AERO SURFACE ROADWAY
 F-LINE EXTENSION

DRAWING NO.
 ET-25

TRAFFIC SIGNAL WORK
 G / MISSION MID-BLOCK

THE EMBARCADERO

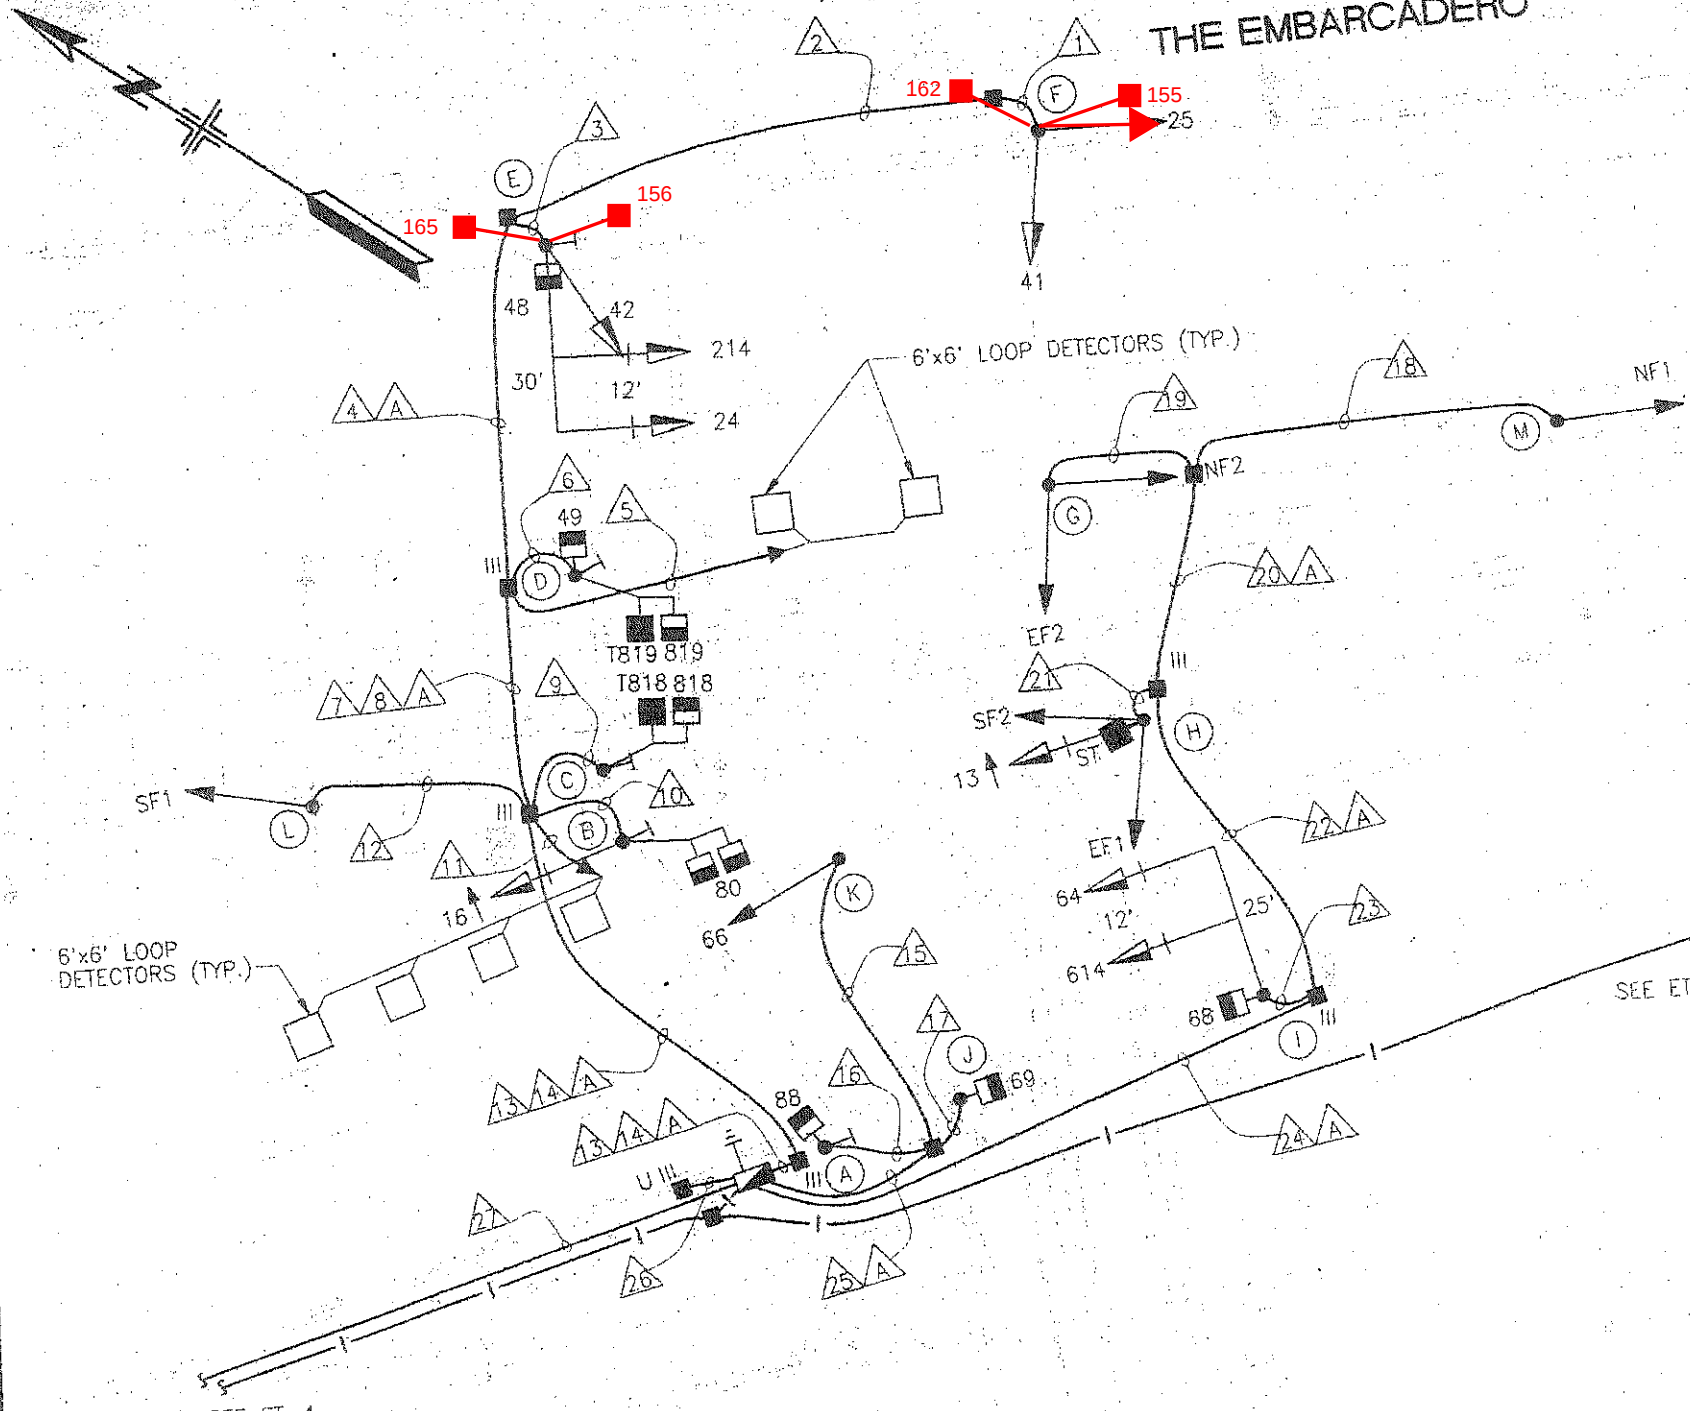
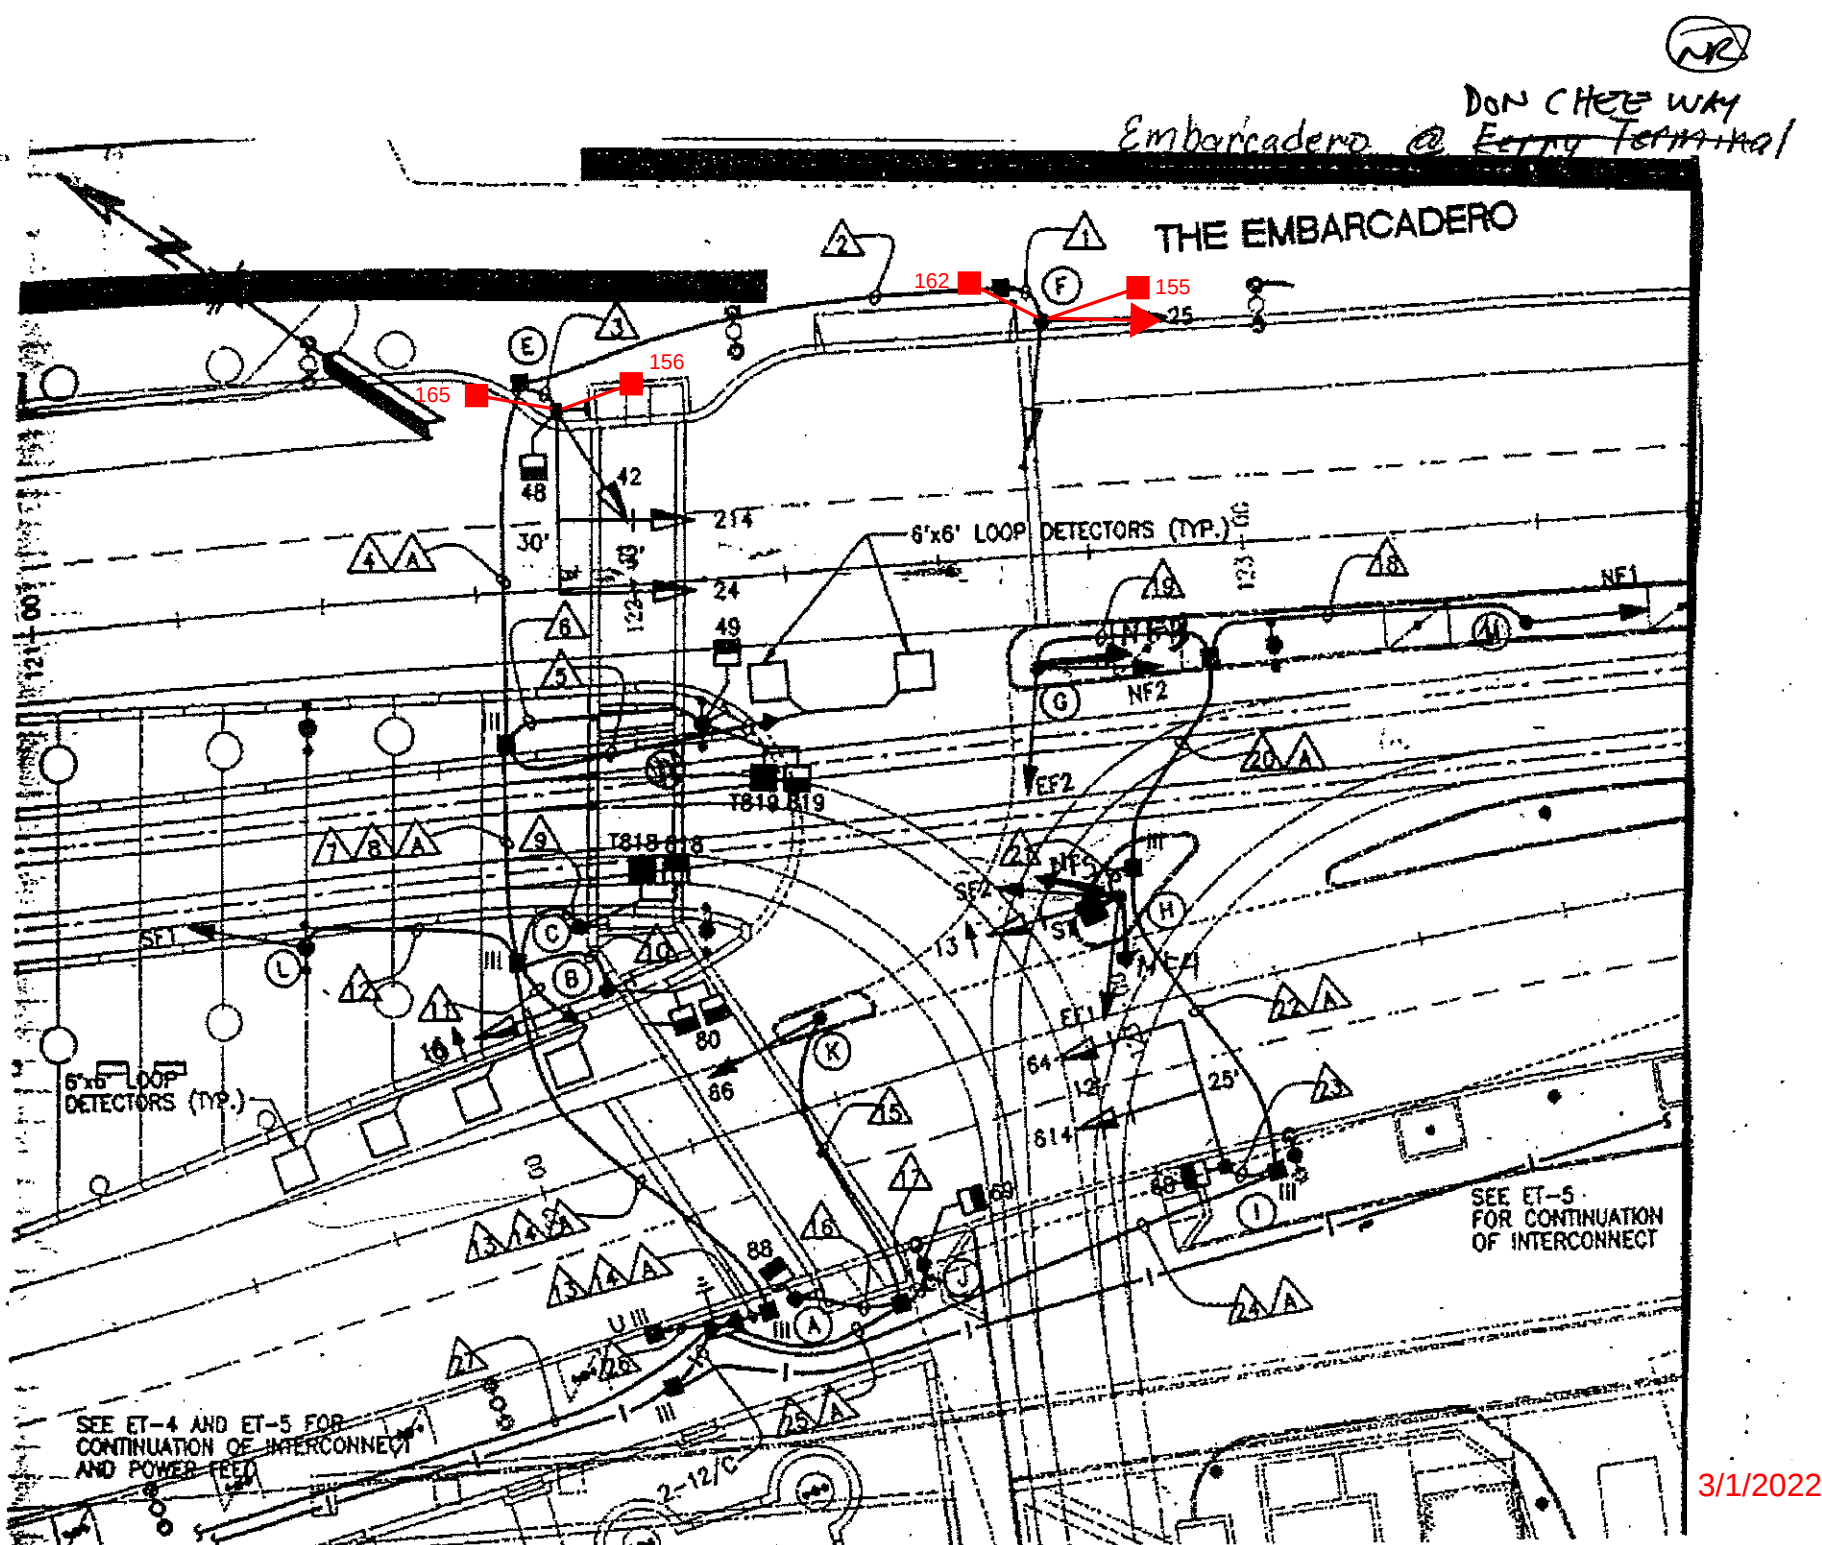
Add signals 155, 156, 162, 165. Update 25 to 3S12" per SRC 2021-300. - G. Ho

Add signals 155, 156, 162, 165. Update 25 to 3S12" per SRC 2021-300. - G. Ho

* Note 1: Custom SV-2-T @ 8' per Figure 1. 151 in Position A
